**2016 Waikato and Bay of Plenty airspace  
review  
Final airspace changes**

This review has comprised all of the airspace detailed on the C3, C5 and C6 visual navigation charts covering the area south of Waihi Beach, westwards to Hamilton control zone-Te Kuiti-Taumarunui, eastwards to Opotiki-Lake Waikaremoana and as far south as Turangi.

Figure 1 – Proposed changes to Rotorua CTR and NZB477

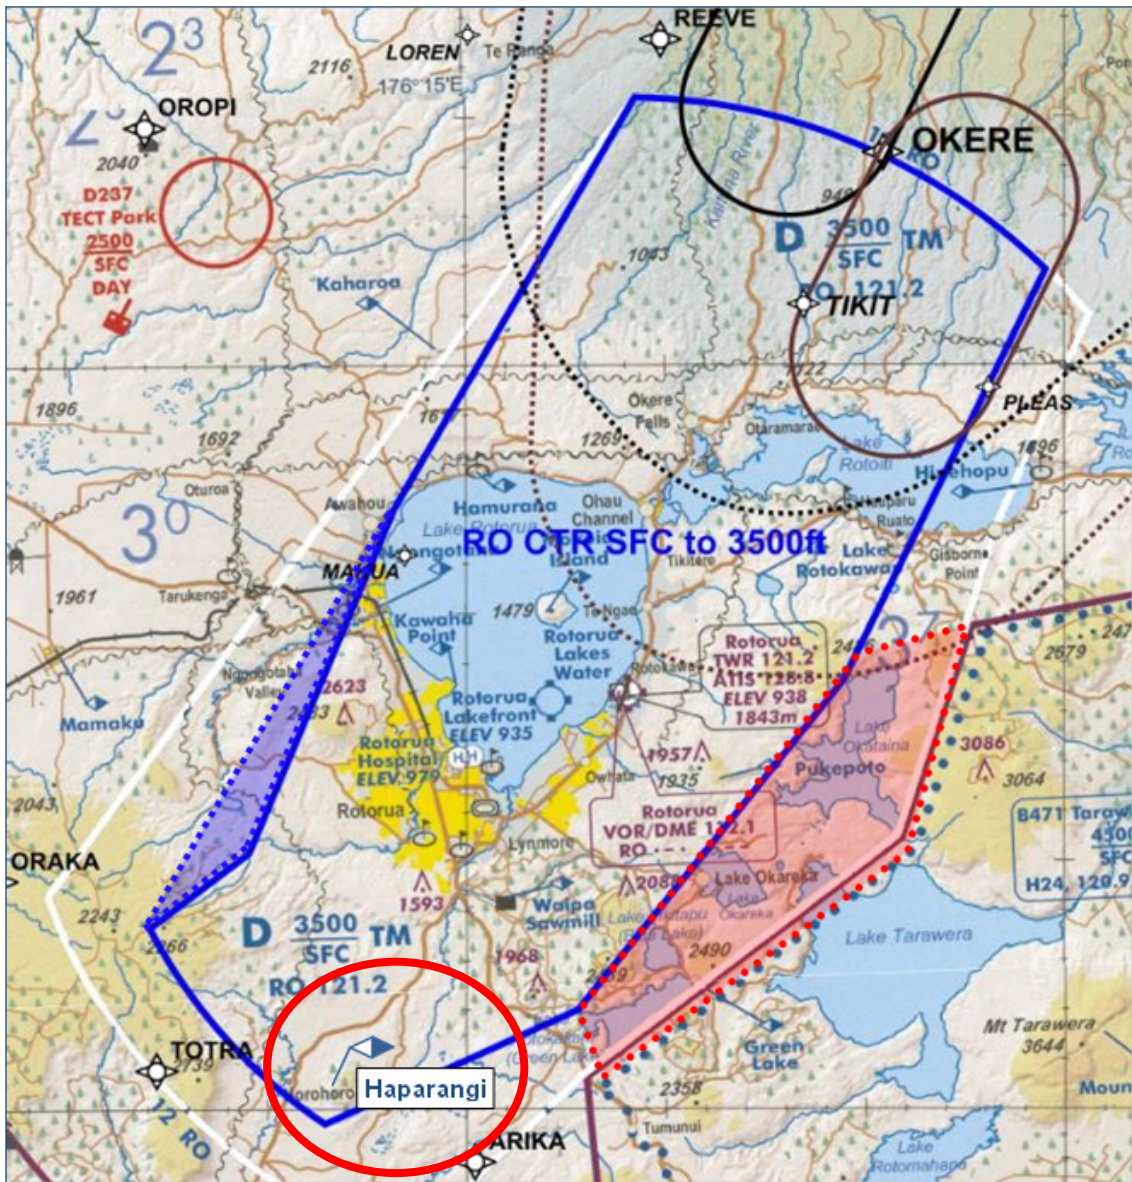
The Rotorua Airport Airspace and Users Group submission requested the following

- A new VFR reporting point at Mount Haparangi, to be called Haparangi.
- Alignment of NZB471 Tarawera western boundary with the proposed south-eastern boundary of the Rotorua CTR.
- Realign the south western corner of the proposed Rotorua CTR as a straight line from Awahou to the south-western corner.

Refer to Figure 1 below. The amendment to the proposed Rotorua CTR is depicted as a dashed blue line; alignment of NZB471 is a dotted red line, new VRP Haparangi within the red circle.

*Figure 2 – proposed amendment to NZG258*

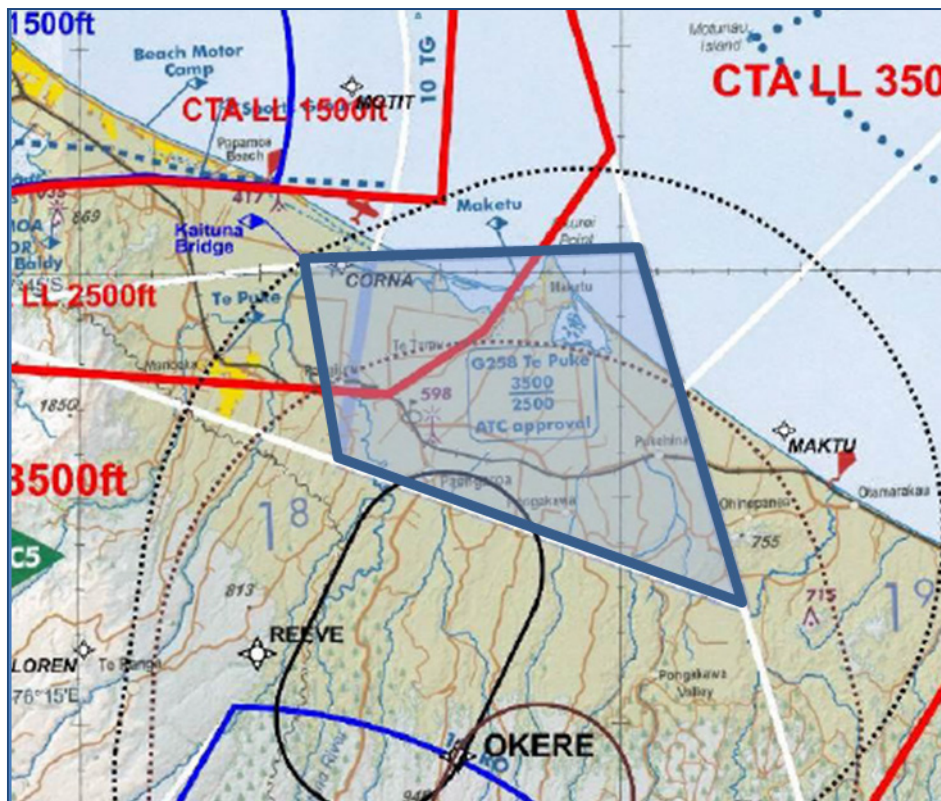
Amendments to the Tauranga CTA would place most of the existing NZG258 outside controlled airspace.

Tauranga users have requested that the upper limit of NZG258 is raised to 4500 ft, and the north-west boundary is moved to Kaituna Bridge (new visual reporting point).

The lower limit of NZG258 would be the lower limit of controlled airspace i.e. 2500 or 3500 ft as applicable. Figure 2 shows the proposed amended area depicted in dark blue.

Figure 3 – proposed new CFZ

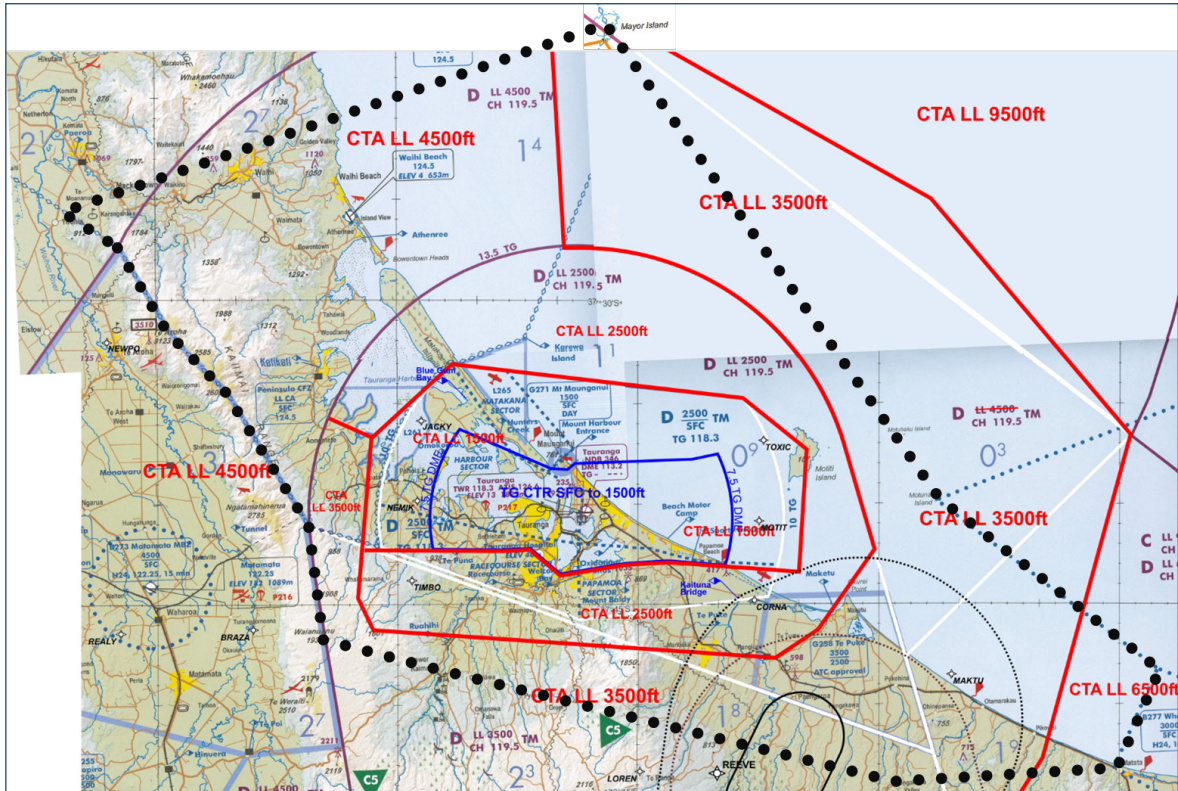
Users at Tauranga have now submitted a request for a new CFZ surrounding the Tauranga CTR which includes the south eastern portion of the Peninsula CFZ south of a line Mackaytown to Mayor Island. Refer below.

The following proposal for a CFZ surrounding the Tauranga CTR is depicted below by the black dotted line in Figure 3. Note that Waihi Beach aerodrome would be part of the new CFZ.

Figure 4 – Three CFZ proposal

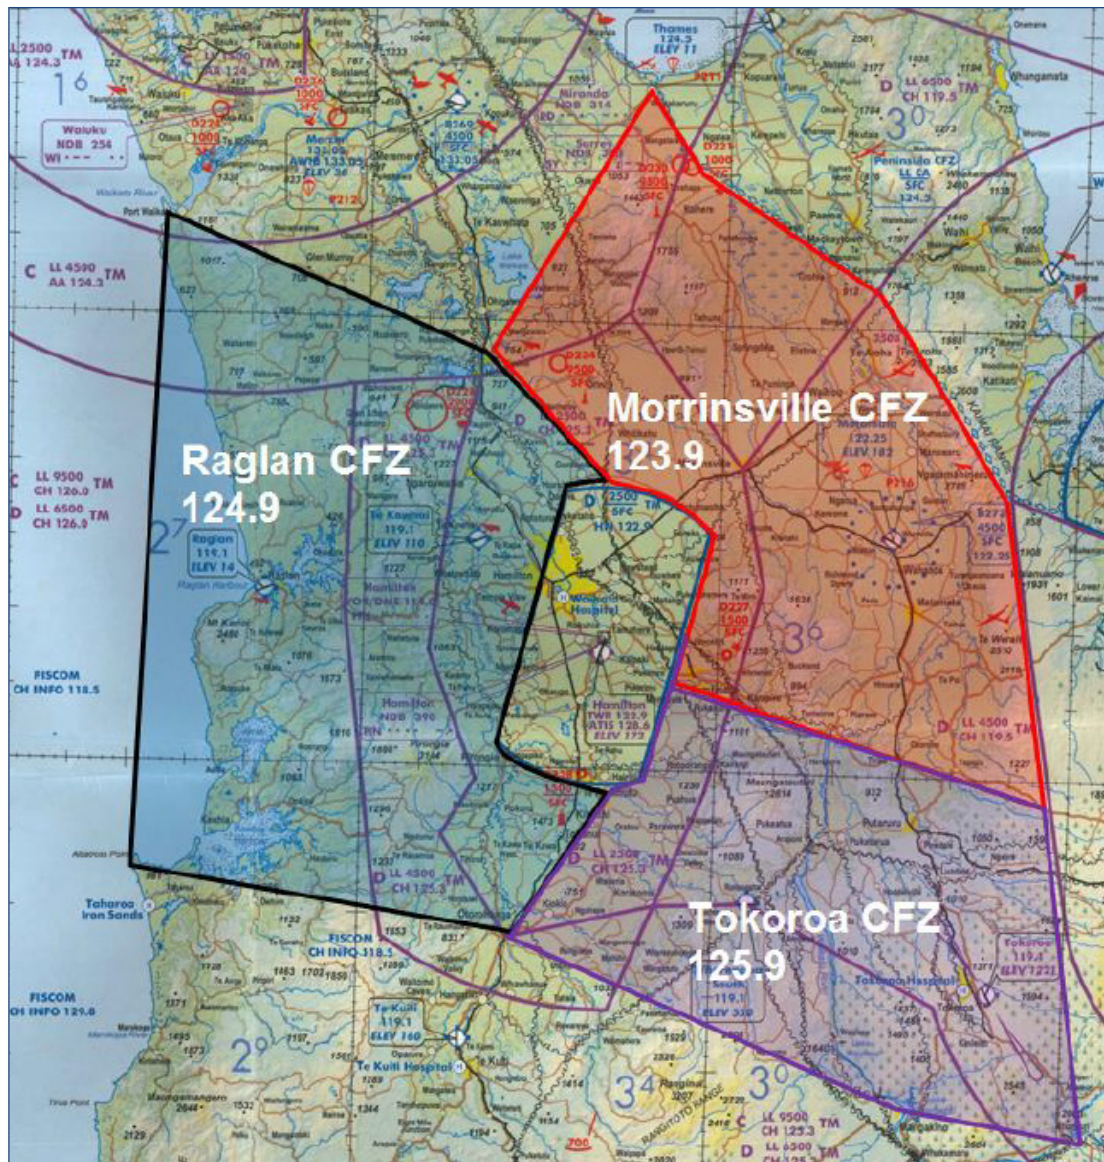
CTC Aviation and Waikato Aero Club have produced proposals for either 2 or 3 new CFZs in the Waikato area. Refer to Figures 4, 5 and 6. Note that the names and frequencies are yet to be confirmed.

CTC note: Morrinsville and Tokoroa boundary is aligned with Cambridge-Tirau-SH5 to Rotorua

Figure 5 – Two CFZ first proposal

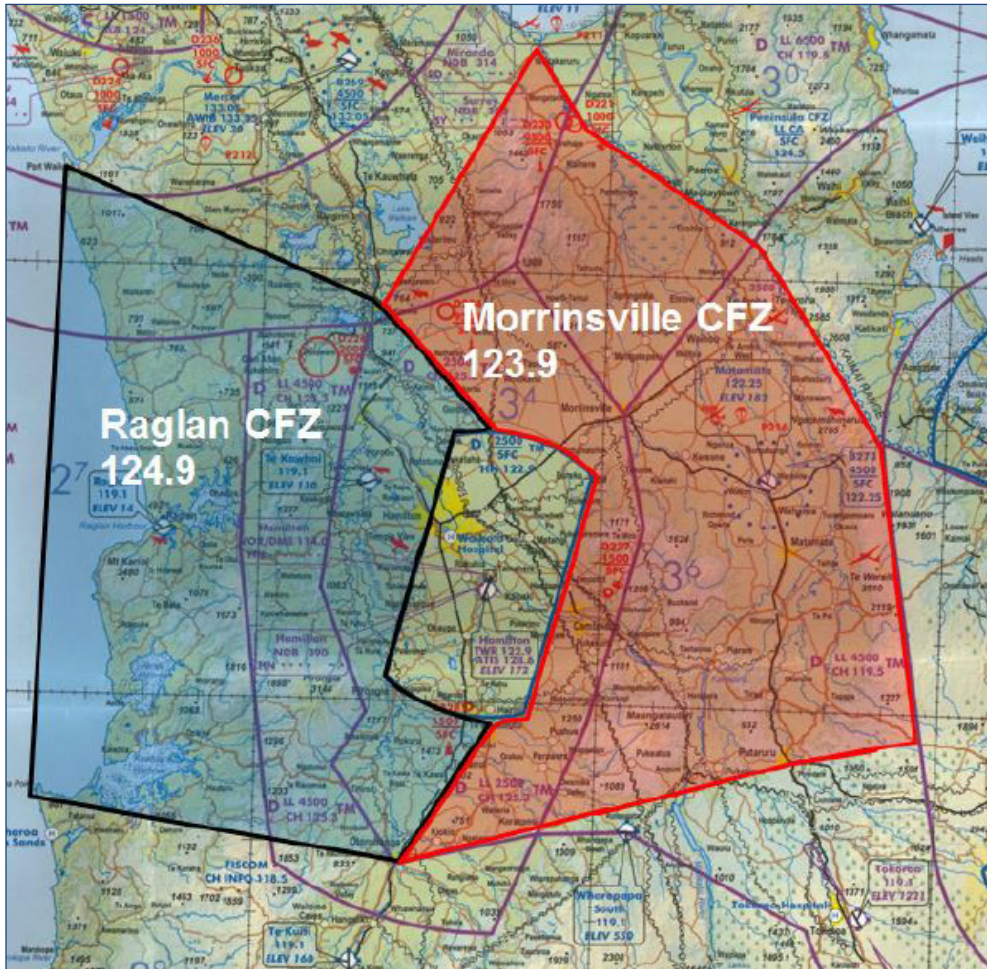
CTC note: southern boundary of Morrinsville aligned with Otorohanga-Arapuni-Putaruru-SH5 to Rotorua

Figure 6 – Three CFZ second proposal

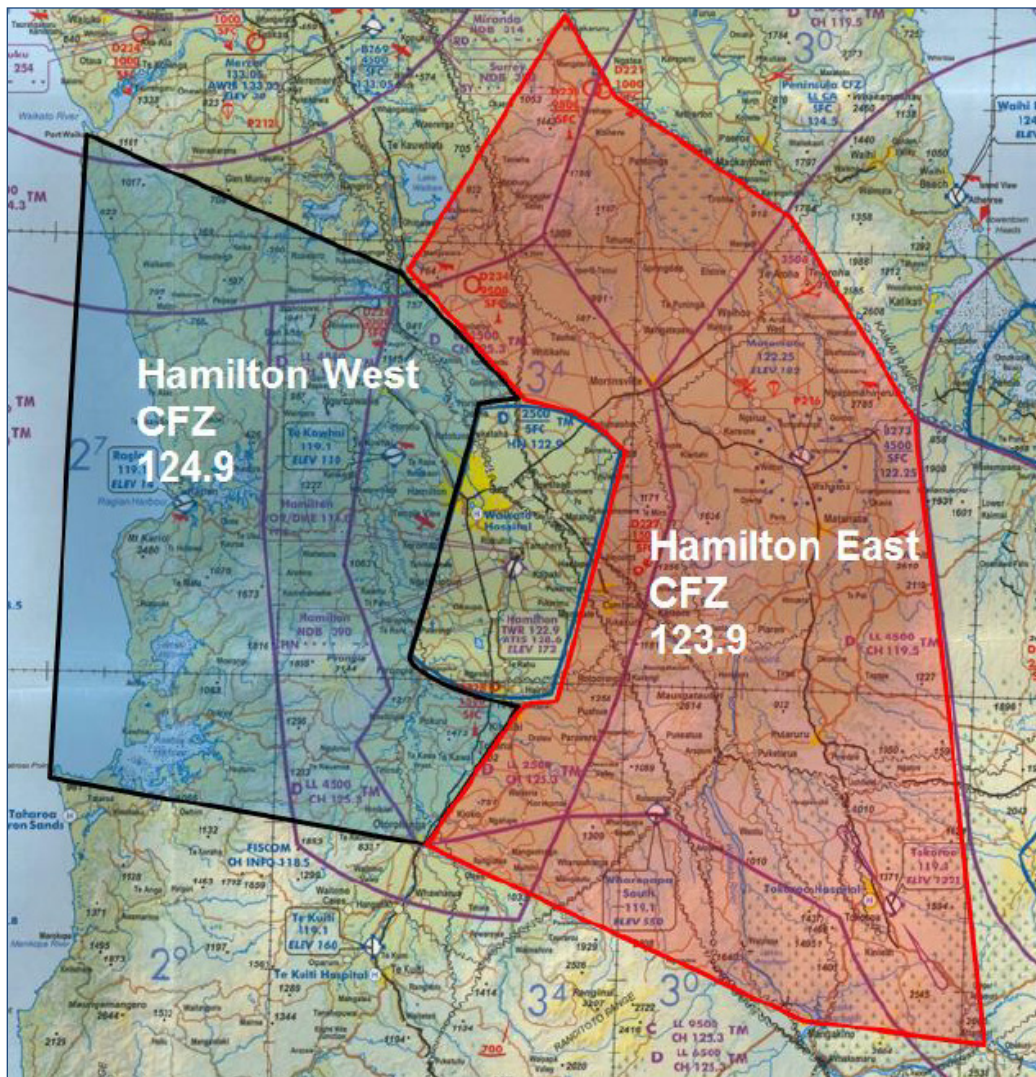
CTC note: large area of Hamilton East may generate substantial volume of radio traffic.
